**AMENDMENT 1 for**  
**RFQ-YEM-0019-2017Solar Shade Structure (Solar Carport) in UNDP Sanaa**  
**office parking area.**

**This Amendment is issued after the site visit arranged as mentioned on UNDP RFQ documents:**

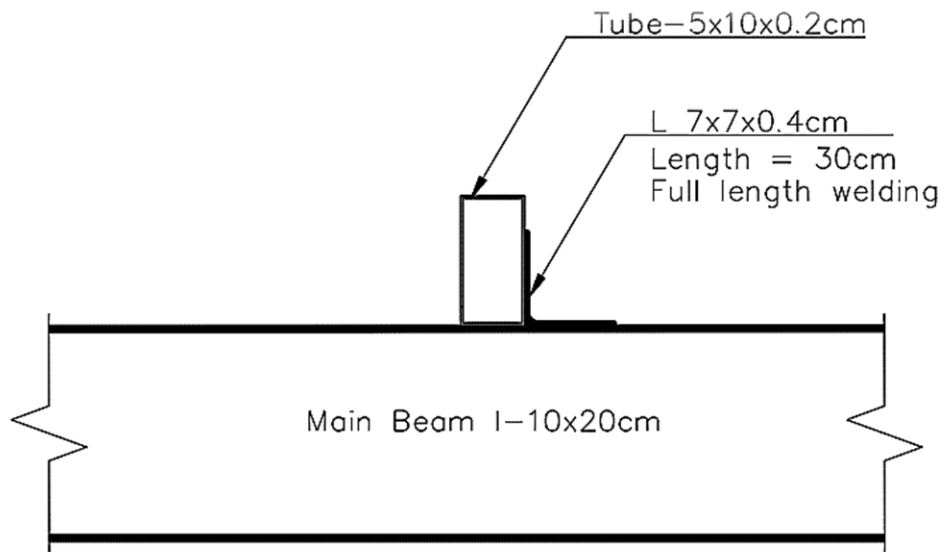
**9. The Solar Panel doesn't mention in the BOQ in Annex 2 So, we can put it in our form or the Solar Panel will include in another Tender.**

The solar panel doesn't include this tender, just mounting system (steel structures includes drawings and BOQ)
